SERVICE BULLETIN No. 6647-32-5

LANDING GEAR - EXTENSION AND RETRACTION - CONTROL AND INTERFACE

INTRODUCTION OF LGCIU Pt. No. 664700500A4B

CLARIFICATION OF LGCIU PART NUMBERING

Figure 1

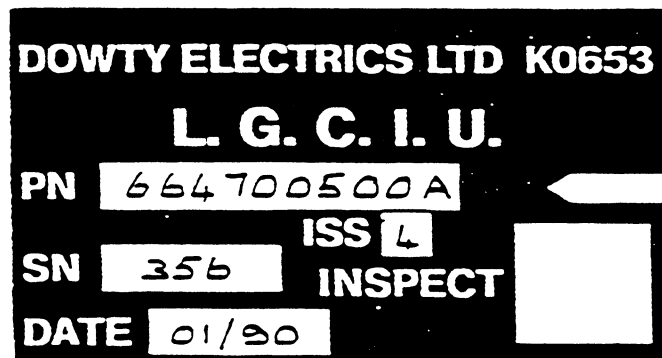
Some LGCIUs have entered service with an incorrect Part Number written on the unit identification label on the front panel. These units have the legend '664700500A4A' written in the PN space on the unit label. The correct legend is '664700500A', the final two digits of the LGCIU Part Number being obtained from the label on the relevant OBRM.

Refer to Fig. 1. If the PN space on the LGCIU identification label carries the legend shown in Fig. 1(b), no action is required. If, however, the legend is '664700500A4A', as shown in Fig. 1(a), proceed as follows :-

- (1) Using a lint-free cloth moistened with iso-propyl alcohol, wipe away any dirt and finger-marks from the LGCIU front panel label.
- (2) Using a small brush loaded with black enamel lacquer to AFS307 (or the equivalent), obliterate the digits '4A', as shown in Fig. 1(b).
